Access Compliance Report

Public Rights-of-Way

(Curb Ramps)

Intersection ID: 17607	Main Street: BRIGHTON_BROOK_DR	Cross Street: GARDEN_GATE_CT	Location:	N
ADA ID: 70B7723C3F1B	Ramp Type: PerpDiag	Initial Pass/Fail: Fail	Overall Compliance: No	Severity Score: 12.5
Codes/Mitigation Info/Possible Solution		Field Measurements/Component Compliance

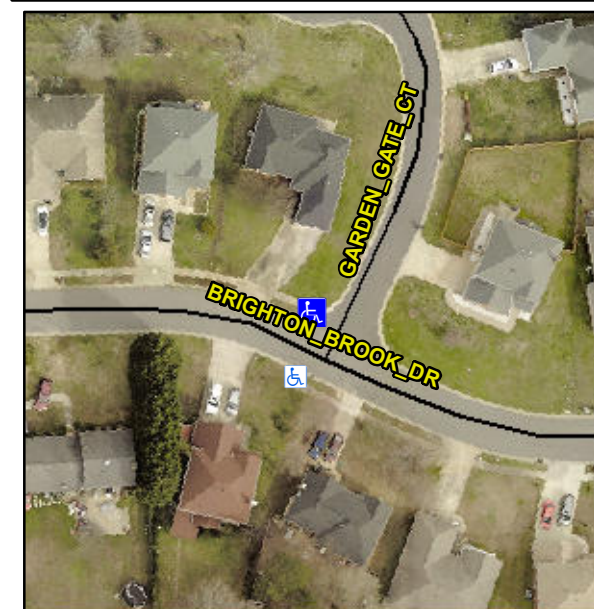
Not Found, R304.5.3

Compliance	Description	Data	Compliance	Description	Data
N/A	Ramp Length (in)	92.0	Yes	Ramp Slope (%)	7.1
Yes	Ramp Width (in)	48.0	No	Ramp XSlope (%)	5.3
N/A	Flare Type LT	N/A	N/A	Flare Type RT	N/A
N/A	Flare Slope LT (%)	N/A	N/A	Flare Slope RT (%)	N/A
N/A	Flare Traversable LT?	N/A	N/A	Flare Traversable RT?	N/A
N/A	Landing Length (in)	N/A	N/A	DWS Provided?	N/A
N/A	Landing Width (in)	N/A	N/A	DWS Contrast?	N/A
N/A	Landing Slope (%)	N/A	N/A	DWS Length (in)	N/A
N/A	Landing X Slope (%)	N/A	N/A	DWS Full Width?	N/A
N/A	Landing Curb? (Y/N)	N/A	N/A	DWS Offset (in)	N/A
N/A	Shared Landing?	N/A			
N/A	Gutter Ponding?	N/A	N/A	Gutter Slope (%)	N/A
N/A	Gutter Lip Ht (in)	N/A	N/A	Gutter X Slope (%)	N/A
N/A	Painted X Walk1?	No	N/A	Painted X Walk2?	No
	X Walk 1 Direction	To SW		X Walk 2 Direction	To SE
N/A	X Walk 1 Width (in)	N/A	N/A	X Walk 2 Width (in)	N/A
	X Walk 1 Slope (%)	0.2		X Walk 2 Slope (%)	0.8
	X Walk 1 X Slope (%)	2.1		X Walk 2 X Slope (%)	5.9

Remove & Replace Curb Ramp With Two New Directional Ramps or Equivalent.
